Sunset Neighborhood Park Master Plan

Open House Meeting #1 Agenda

Date: May 1, 2014

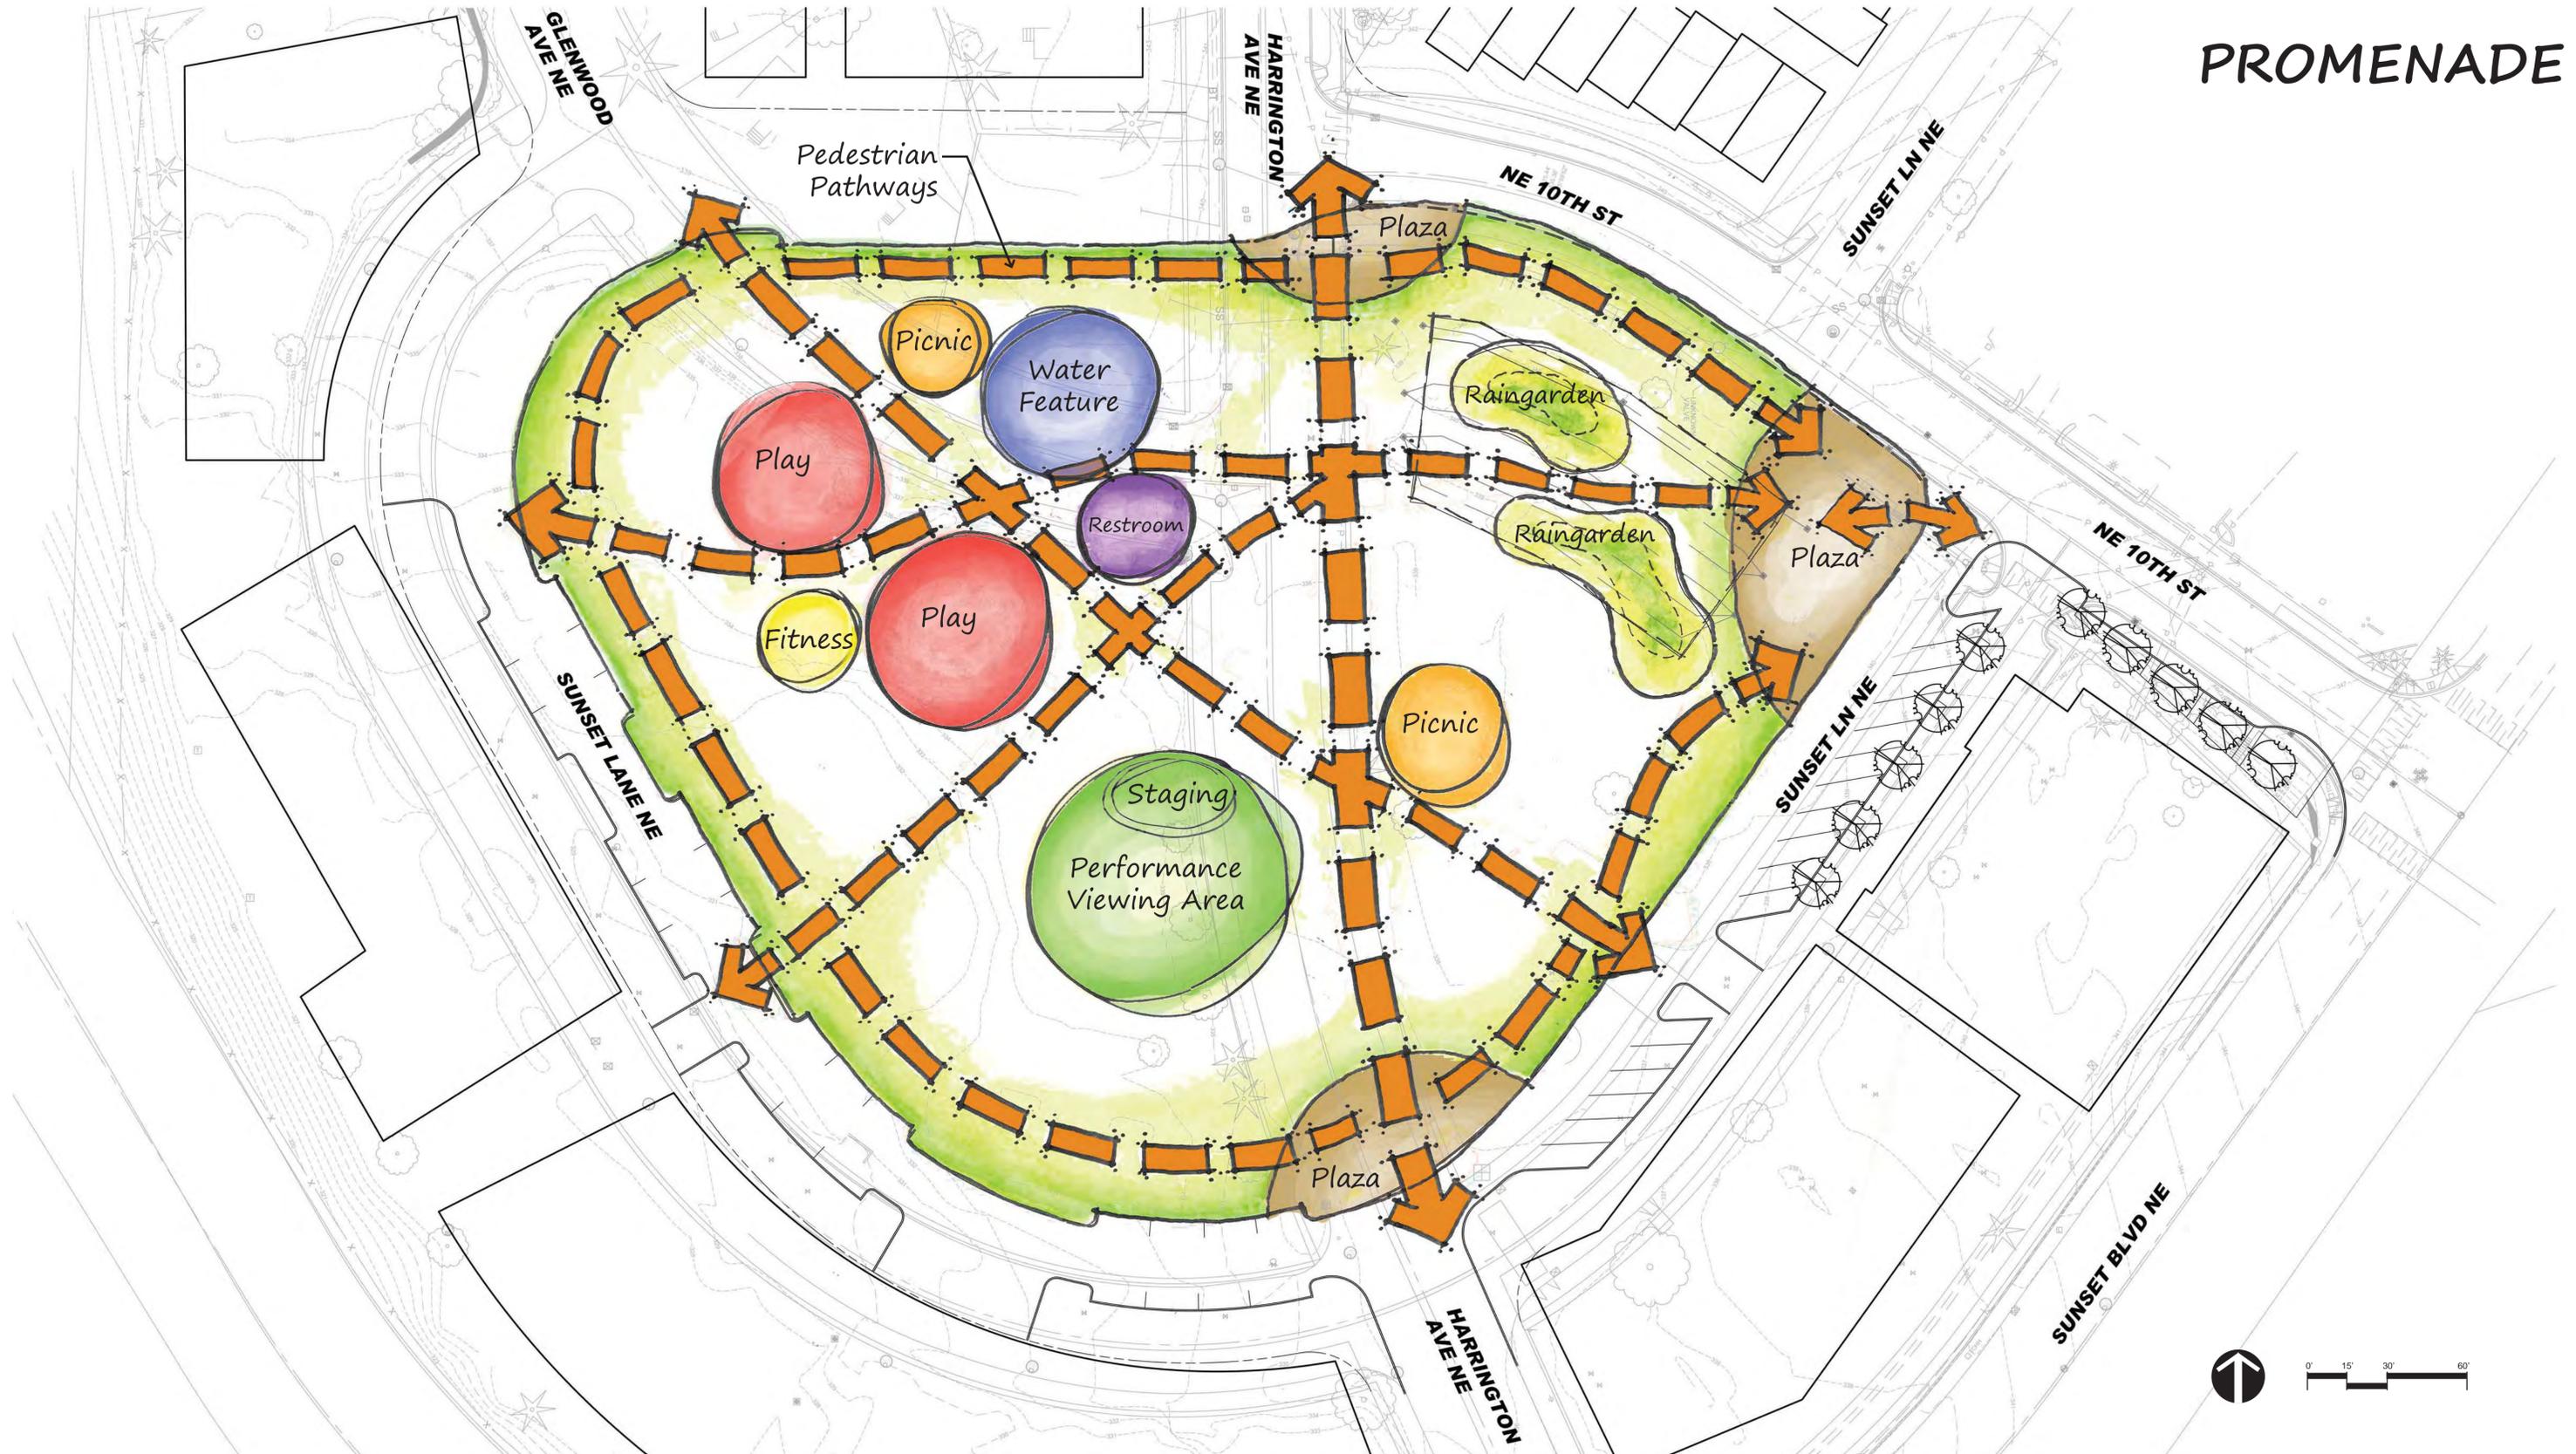
Collectively the two discussion groups preferred the circulation in "Promenade", and favored the placement of park components in both "Portal" and "Flow". Participants liked the direct circulation routes in the "Promenade" concept and liked the many entrance points in the "Portal" concept as well as the placement of activity near the commercial side of the park in the "Flow" concept.

- 1) "Cluster" pros: The play area is centrally located. The hill is nice.
"Cluster" cons: The park components are too centrally clustered on top of each other, and do not create opportunity for discovery. There is too much open space, which is weather-dependent.
- 2) "Portal" pros: The plazas provide opportunity for meeting and children pick-up locations. These plazas could each have themes. The hierarchy of the plazas read well, and could be applied to the

“Promenade” concept. The water feature is centrally located.

“Portal” cons: The water feature potentially blocks a thru-path. Paths do not connect across the park. Activities are too tightly clustered. A picnic area is needed by the play area.

- 3) “Flow” pros: The paths are simple and work well. The activities near the library and retail are well located.

“Flow” cons: There is too much open space. The performance space is located too far from the library.

- 4) “Promenade” pros: The relationship to the library and retail works well with the path layout. Two picnic areas are useful. The restroom is centrally located.

“Promenade” cons: There are too many paths. The picnic areas are too far from the restroom.
